STATE OF IDAHO  
DEPARTMENT OF  
ENVIRONMENTAL QUALITY

September 19, 2007

RE: Modeling Protocol for the Bennett Lumber Products Facility Located near Princeton  
Idaho

**Figure 2 Bennett Lumber Emission Sources, Building, and Property Boundary / Public Access Limits**

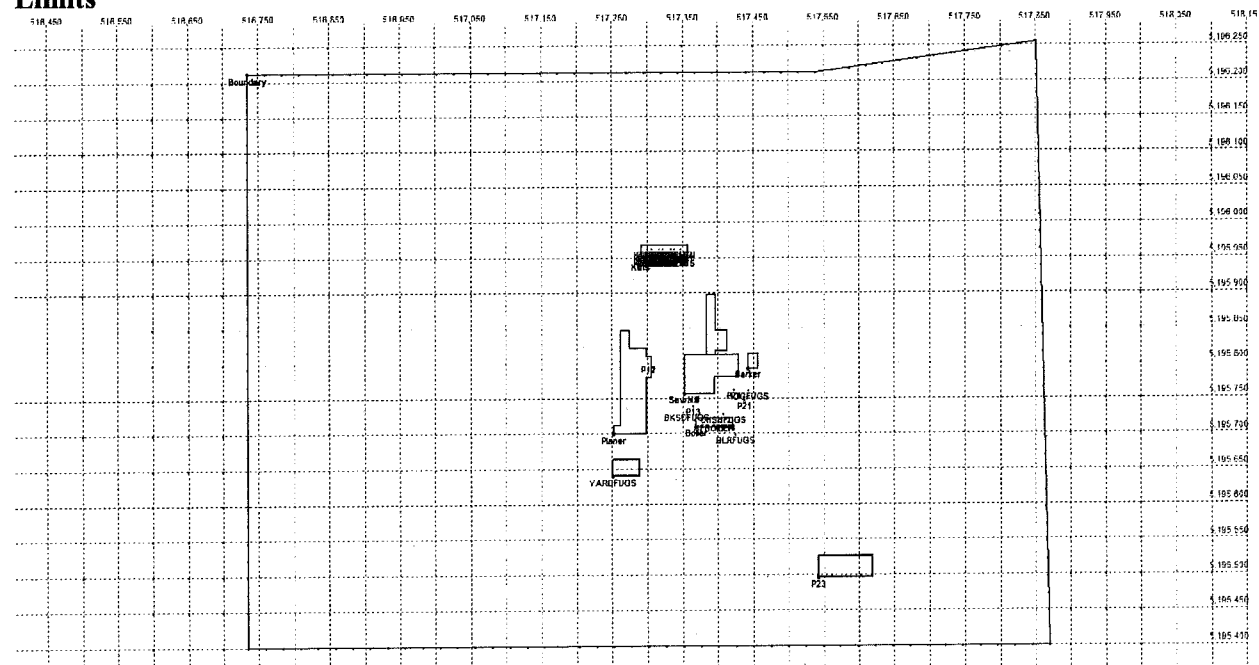
- Comment 1: The protocol provides tabular documentation and narrative justification for stack parameters used in the modeling analyses. All six process material handling units consisting of five cyclones and a baghouse are now understood to exhaust horizontally or with the exhaust impeded by a raincap. This information needs to be presented on an emission point-specific basis, not a general statement.
- Comment 2: DEQ accepts BLP's assertions supporting the ambient air boundary described in the modeling protocol in Section 5—Model Domain, Mapping, and Receptor Network. This section states, in part, that "the entire perimeter of the facility is fenced or gated." This is an appropriate measure for deterring public access from the area you have defined as the facility property.

Comments made by BLP during the September 5, 2007 conference call between representatives for BLP, CJ Environmental, and DEQ indicated that no trespassing signs are located on the banks of the Palouse River where the river crosses the facility perimeter. Please include this statement in your ambient air boundary determination description in the permit application's modeling report.

In the event the State of Idaho Department of Lands formally includes this section of the Palouse River on its list of "navigable rivers" BLP's ambient air boundary will need to be updated to include the river as ambient air for the purposes of demonstrating compliance with applicable National Ambient Air Quality Standards. Also, in the event a member of the public successfully challenges BLP's claim to this section of the Palouse River through the appropriate legal means under the State of Idaho Fish and Game

Recreational Trespass statutes, the ambient air boundary will need to include this section of the Palouse River as ambient air for NAAQS compliance.

1. We added a column in Table 1 identifying each stack as default (vertical and unblocked), rain capped, or horizontal
2. We added in a statement I verify on public access signage verified by onsite staff
3. As noted during the original permit application, the IDEQ MI forms don't allow copying in data from spreadsheet formats like BEEST because they are programmed with multiple cells per entry, and they do not accept hand entries on my computer for some non-understandable write permission reason. Mary Anderson of IDEQ agreed in writing that we could submit the information on our own spreadsheets, which we did previously and again here. Submitting the BeeLine BEEST file alone, as we did before and will do again, meets that requirement. We also provide Table 1 in a spreadsheet form (file MI Model Source data.xls), which was prepared by copying source data from BEEST into a spreadsheet)
